DAVID PLUMMER & ASSOCIATES

**Re: Mediterranean Village Review - #14153
Traffic Impact Study, Parking Analysis & Valet Operations Analysis**

David Plummer and Associates (DPA) have completed several reviews of the Traffic Impact Analysis, Shared Parking Analysis, Parking Garage, and Valet Operation Analysis conducted for the proposed Mediterranean Village project. A summary of these components is below.

HOTEL DROP-OFF - OPTION #3 "STAFF RECOMMENDATION"

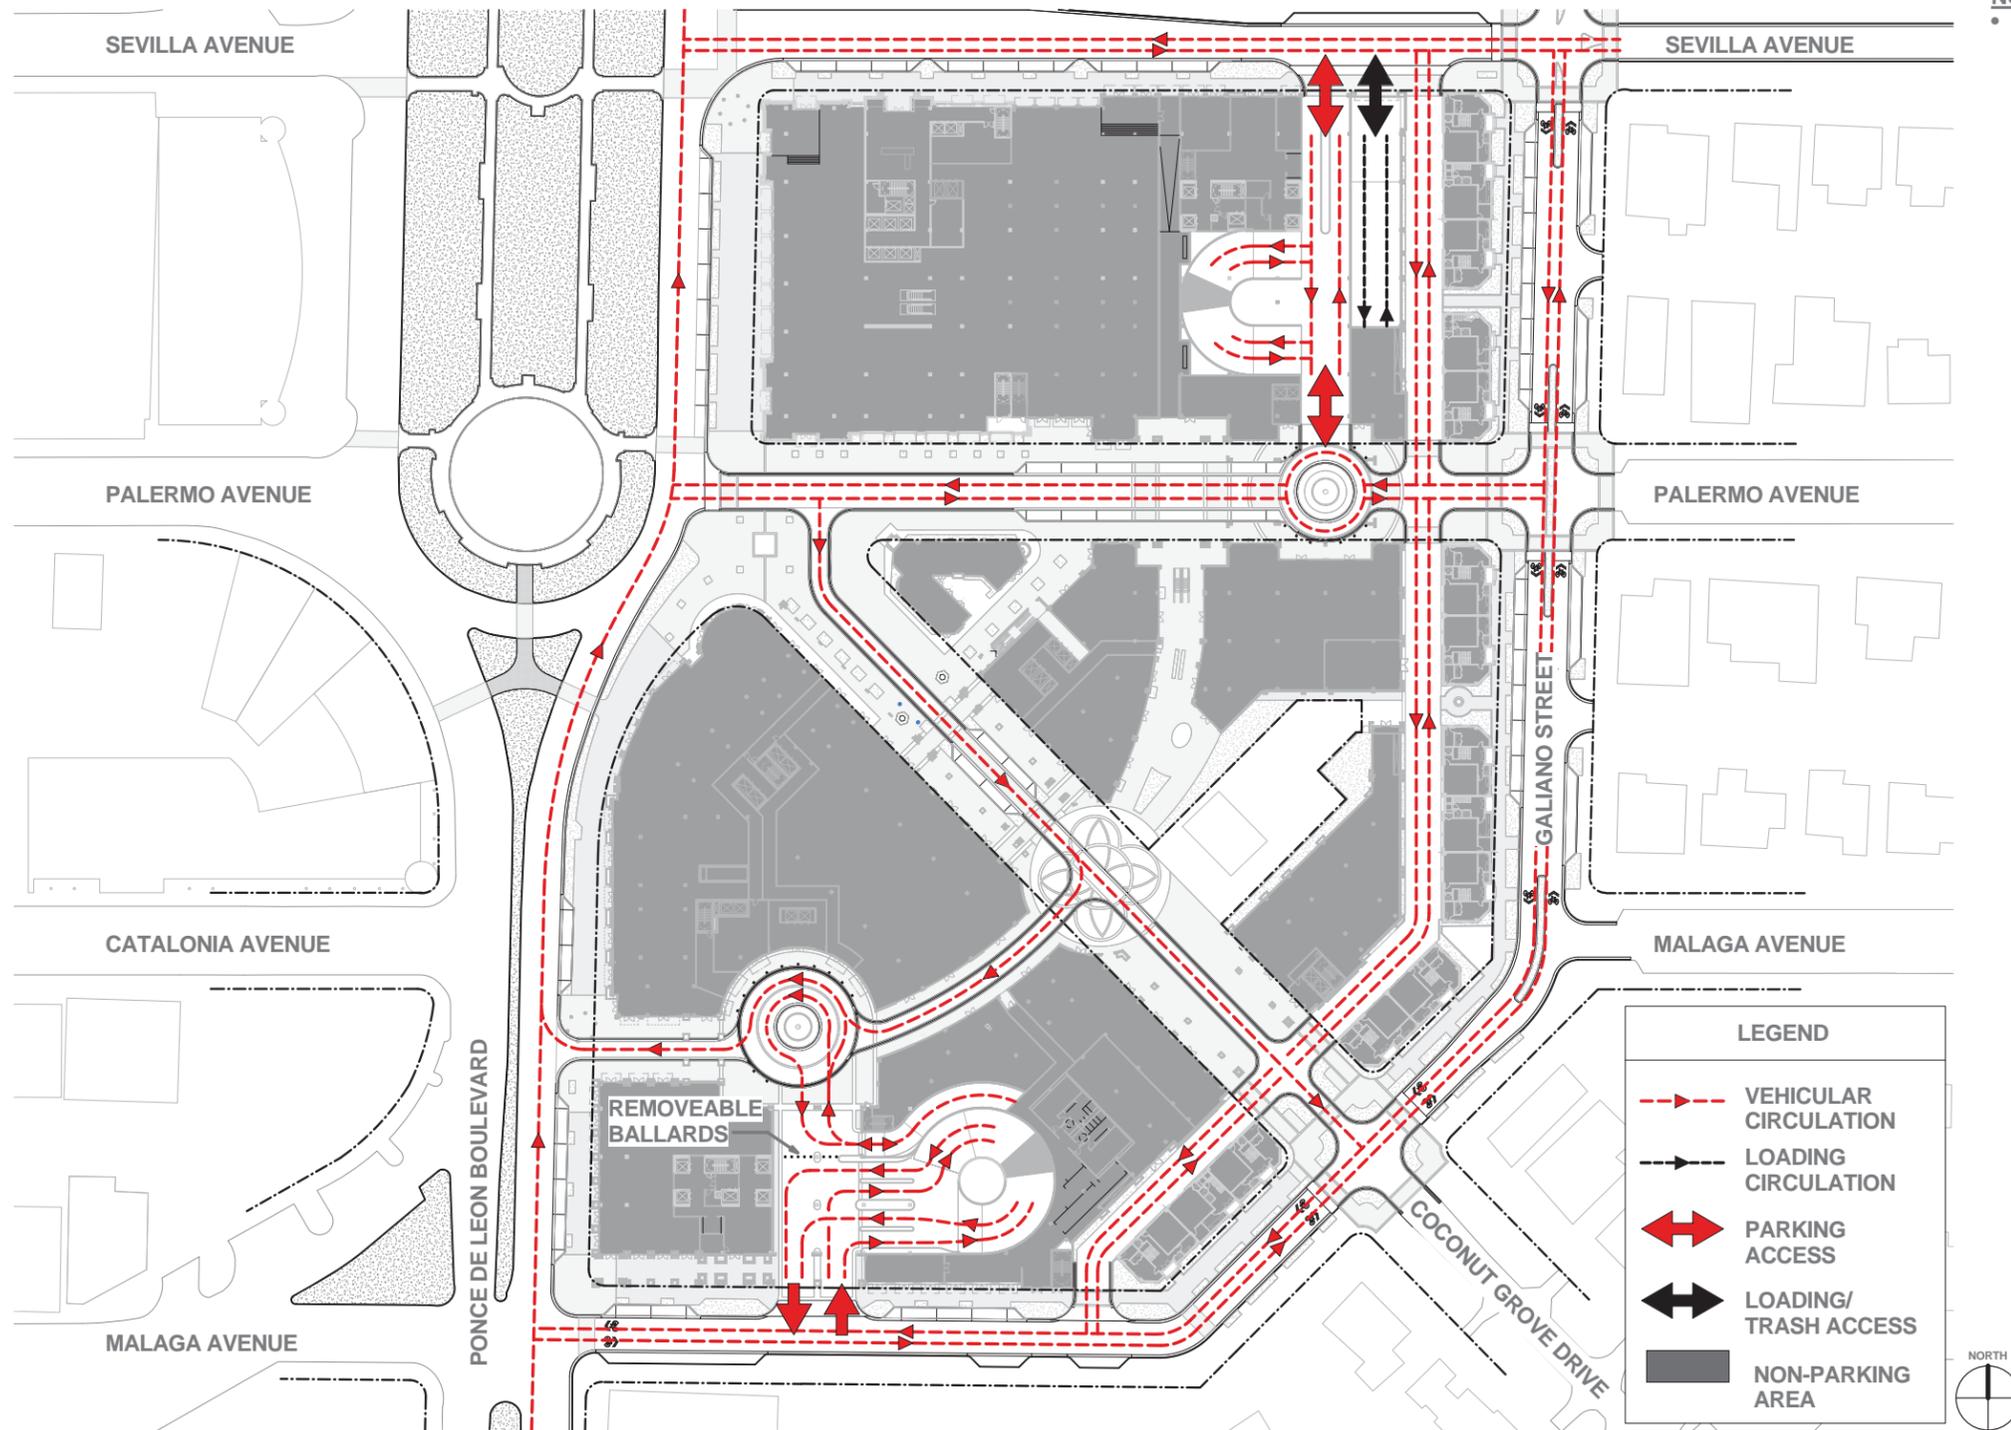
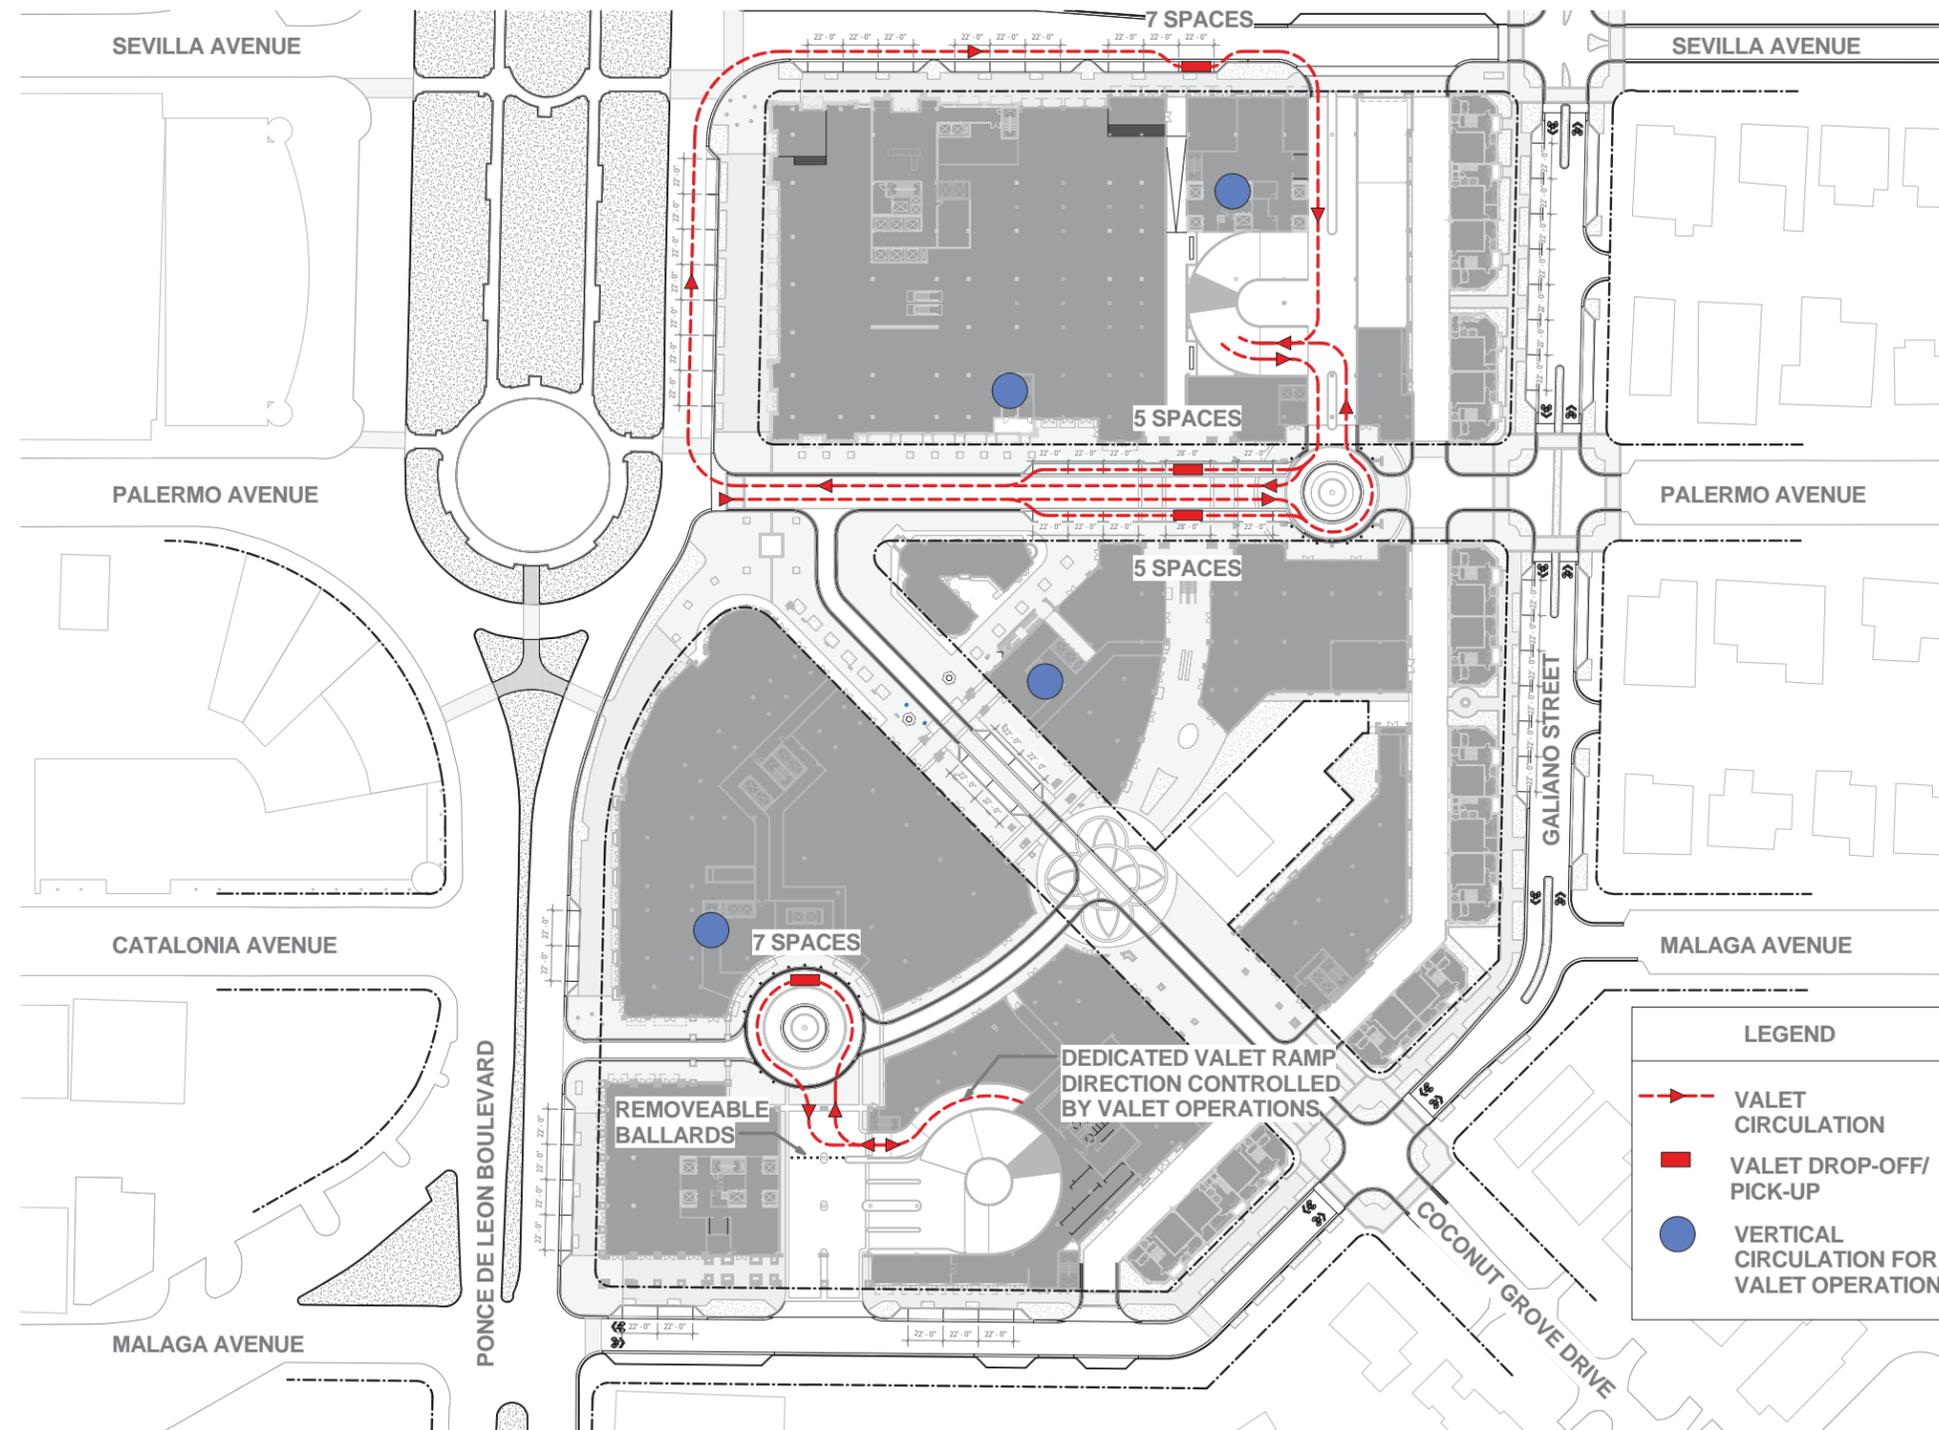
During first reading, the project included direct access to the hotel from Ponce. This access plan for the hotel was acceptable. The project has since changed to address comments from the Commission. Of the newly proposed options, Option 3 is an acceptable alternative and preferable to Option 2 provided that the following conditions are included: 1) the hotel valet ramps will be completely segregated from the Malaga driveway ramping system and no traffic from Malaga would be allowed to access the hotel's porte cochere, and 2) two one-way ramps (similar to the Ponce alternative) or a two-way, two-lane ramp for hotel valet use only is provided. See attachments for hotel access options.
